MEMORANDUM

**2015 Uniform Plumbing Code
TIA # 002-15
Final Ballot Results**

UNIFORM PLUMBING CODE TIA FORM™ - 2015

Reference Code Sections: 205.0 and 911.0

Figure 1 Circuit Vent

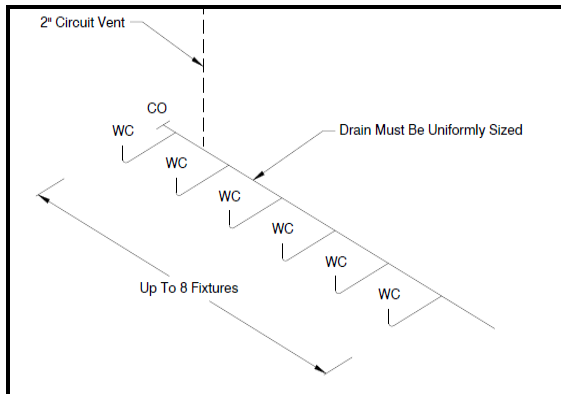
- The figures illustrate the intent of the proposed code language. **Figure 1** displays the basic requirements of where the circuit vent needs to connect to the horizontal branch, the maximum number of fixtures allowed, and the uniform sizing of the horizontal branch. **Figure 2** displays trap arm distance requirements. **Figure 3** illustrates multiple circuit vented branches. On one horizontal branch, the first group of eight fixtures include six water closets and two floor drains. Assuming emergency floor drains with 0 fixture units, the upstream circuit vent is two inches serving the first group of 24 fixture units. The downstream circuit vent is two inches, serving the second group of four water closets and one floor drain having 16 fixture units. Where the two circuit vents connect, Table 703.2 requires the vent size to increase to three inches serving 40 fixture units. **Figure 4** displays the requirement of a relief vent needed when there is a battery of toilets discharging into a stack receiving waste from above.
